<div>marantz®</div> <div>SERVICE BULLETIN</div>		Date: 17-Jul.-2002	Model: PM4200
		Page: 1/2	REF.NBR: MZ02-009revision
		Subject: Problem with incorrect operation of MUTE.	
Circulation:	Application:	Int.ref:	
x for information customer complaint in case of service mandatory	See below

Processing figure (Part side view)

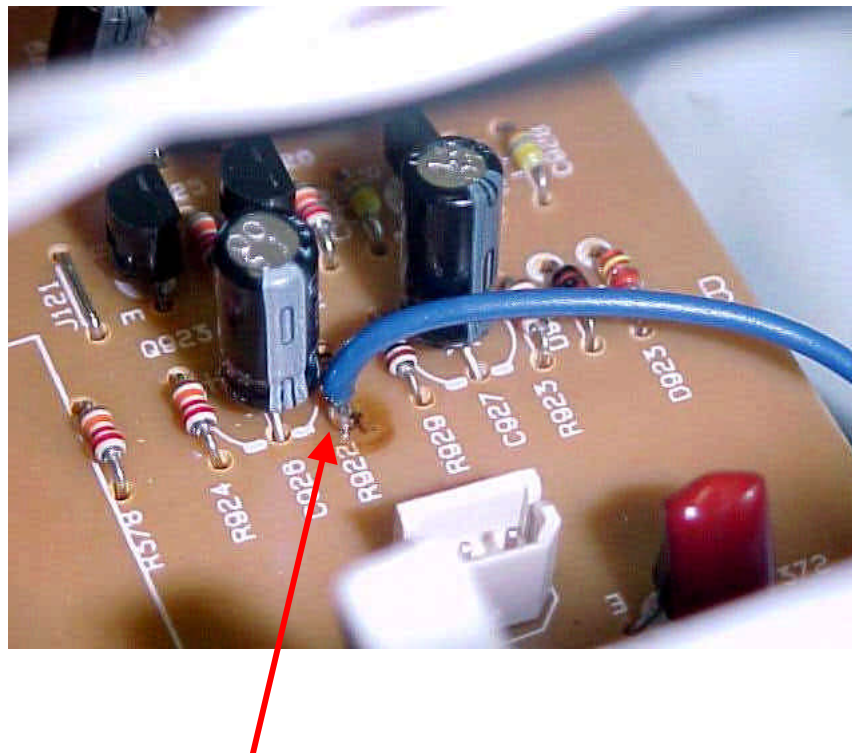
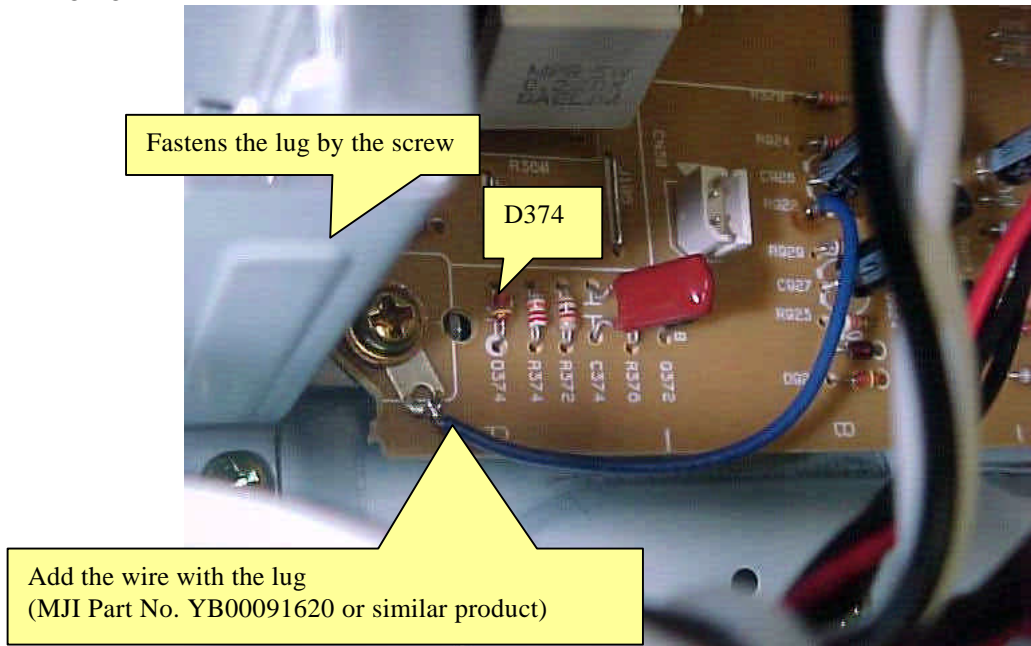
The MUTE LED sometimes blinks and the sounds from output intermit.

Contact error between the bracket (Pos. No. 30) and the ground of INPUT/AMPLIFIER PCB (Pos. No. 29).

Repair work was changed. This work is done without removing a circuit board.

Contact to the ground certainly by the wire with the lug.

Solder the wire to the ground side lead of the R922 or R929
